## **RE: Peer Review of Kariong Sand and Soil Supplies Air Quality Impact Assessment**

Todoroski Air Sciences has been engaged by five nearby landowners of Acacia Road and Debenham Road, Somersby (Lot 3 239 Debenham Rd East, Somersby, 252 Debenham Rd East, Somersby, 242 Debenham Rd East, Somersby, 10 Acacia Rd, Somersby, 12 Acacia Rd, Somersby), to conduct a peer review of the Kariong Sand and Soil Supplies – Proposed *Development Air Quality Impact Assessment (Northstar Air Quality, 2020)* (hereafter referred to as the AQIA) and relevant documentation associated with the Environmental Impact Statement for the proposed development of the Kariong Sand and Soils Supplies site (hereafter referred to as the Project).

Figure 2: AERMET generated windrose

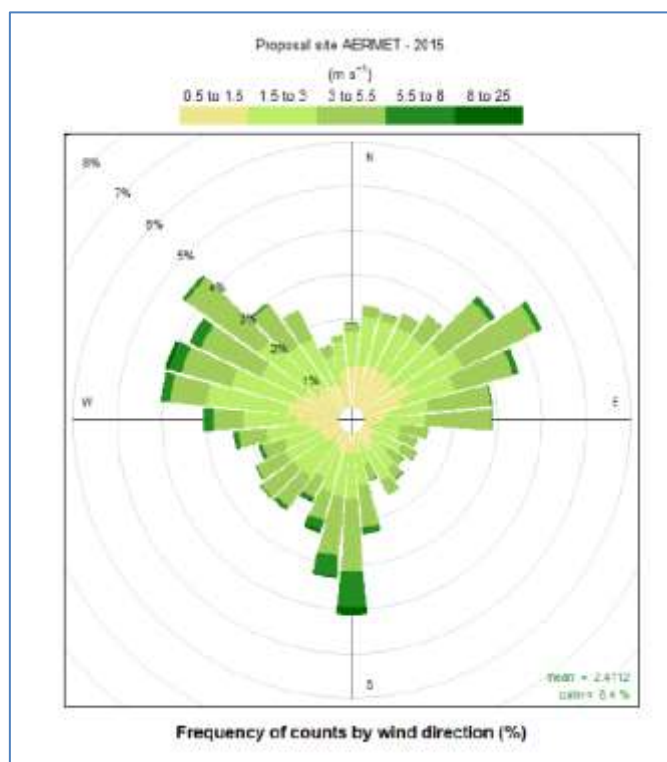
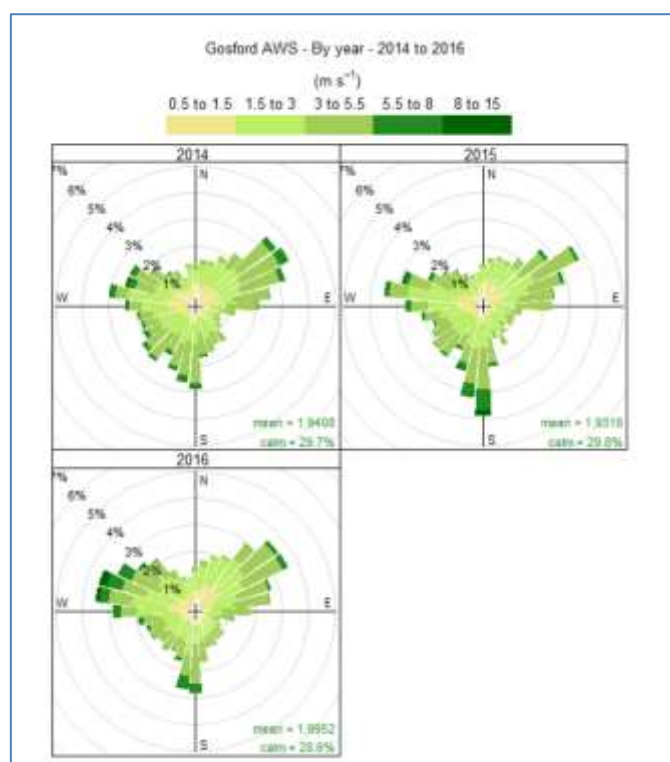
The AERMET generated windrose is presented in **Figure 2** and for comparison, **Figure 3** presents the Gosford AWS windroses. The AERMET windrose shows similar wind patterns to the Gosford data.

It is to be noted that the Gosford AWS station is located in flat terrain near sports fields, north of a large body of water, and south of a steep wooded ridge which runs approximately east-west. On the other hand, the project site is positioned on the western ridgeline or plateau at a significantly greater elevation to the Gosford meteorological station, and does not have elevated terrain to the north, or flat level terrain nearby or to the south.

Due to these significantly different geographical features, the winds at the project site will be significantly different to those as Gosford AWS. These different features will necessarily cause the project site and monitoring station to experience significant meteorological conditions, that is, wind speed and wind direction will be affected by different anabatic and katabatic processes, differing nearby land surfaces and will be subject to different southerly and northerly flow and wind speeds.

likely (as we see in the windrose), the steep wooded ridge to the north will block northerly winds, and enhance NW and NE winds (as is the case)<sup>1</sup> (see **Figure 4**). It is important to note that there are no such features at the project site (see **Figure 4**), hence there will be different wind conditions, and there is no reason to expect similar wind conditions at the project site to those at Gosford AWS. However, the AERMET modelling shows no significant differences between the site windrose and the Gosford AWS windrose.

This means the AERMET data used in the air dispersion modelling is not representative of the project location. This is acknowledged in the AQIA which says *“Although the data do not represent site specific conditions (i.e. at the project site), no data is available to allow an assessment of that meteorological environment”*. It is important to note that unrepresentative meteorological data may cause invalid or incorrect dust modelling results. Meteorological modelling by the reviewer has been made for a location near to the project site, shown as “CALMET Extract” in **Figure 4**. These data can be used for a relative comparative assessment of the meteorological environment near the project site. A windrose showing the reviewer’s results is presented in **Figure 5**, and is provided to indicate the weather conditions which are more likely to be experienced near the project site as may be expected due to the geographical features near the project site. It is also noted that due to differing geographical features in the area, there will also be some difference between different locations along the plateau or ridgeline also, however these local geographical differences would be smaller than those between the project site and the location of the Gosford AWS.

**Figure 5: Indicative windrose at “CALMET Extract” location, likely more representative of the project site.**

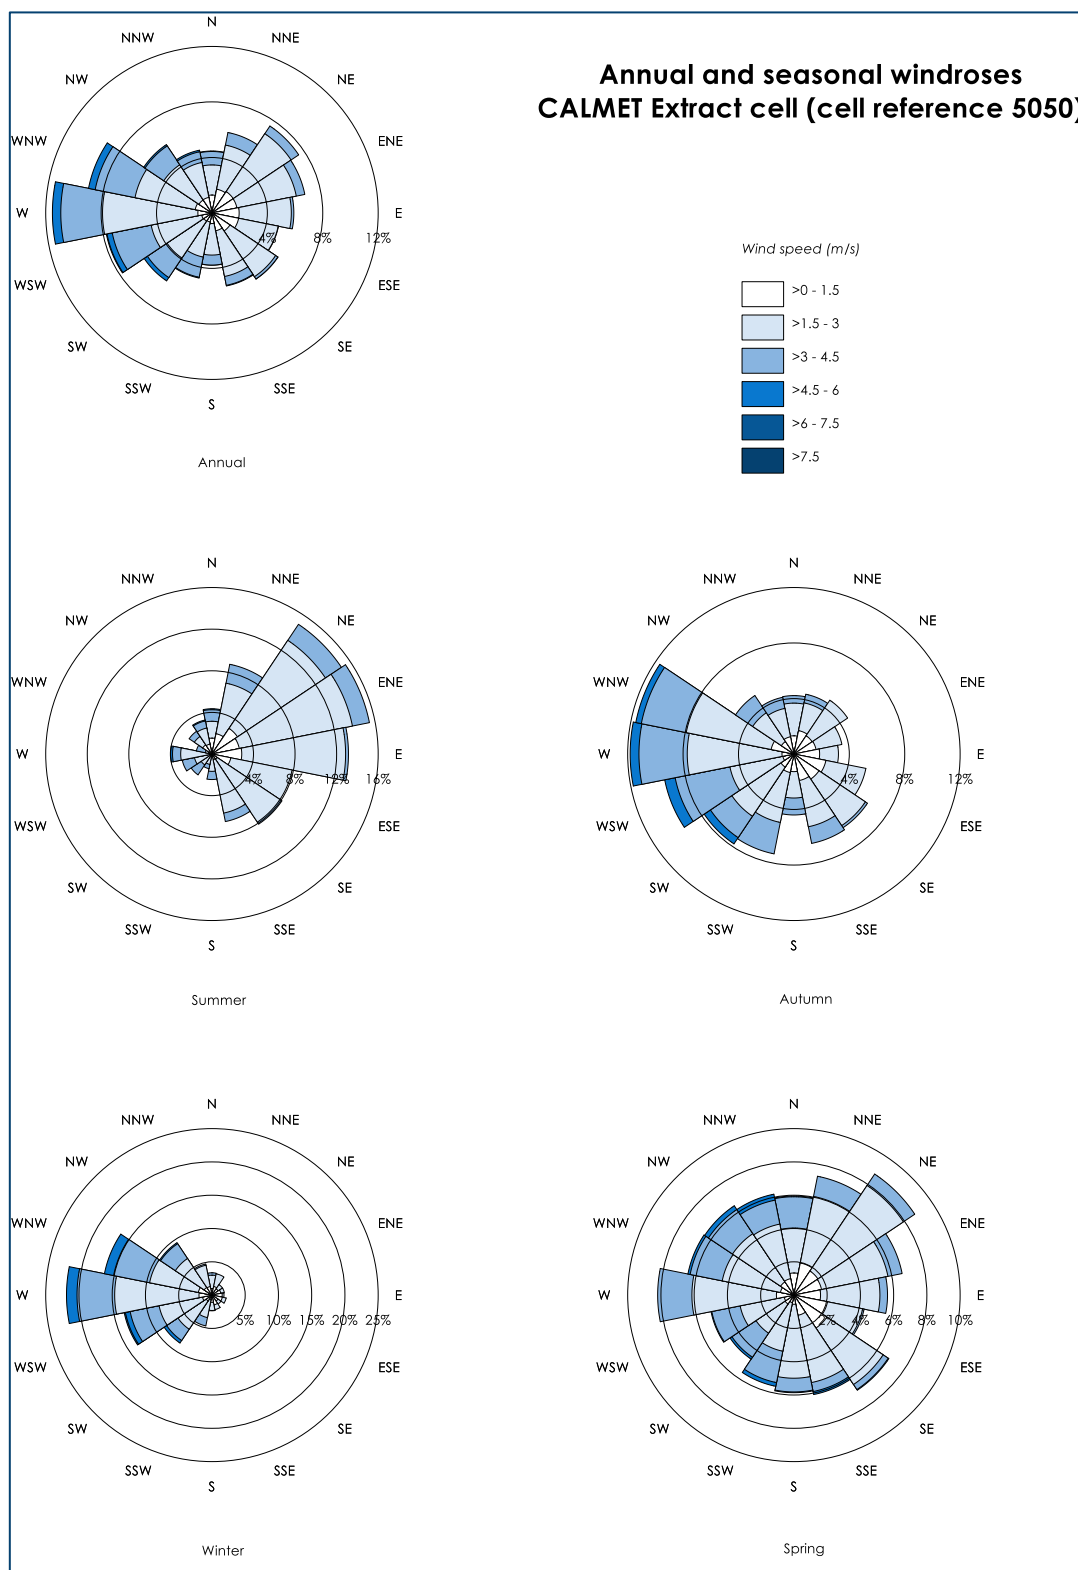
The indication from the above is that relative to the modelled winds, there are likely to be less southerly winds and more westerly winds present near the project site, i.e. more winds towards the nearest receptors. This is especially the case in the winter time, which generally tends to coincide with the poorest air dispersion.

Thus, the weather inputs and model used have potential to lead to invalid or incorrect results.
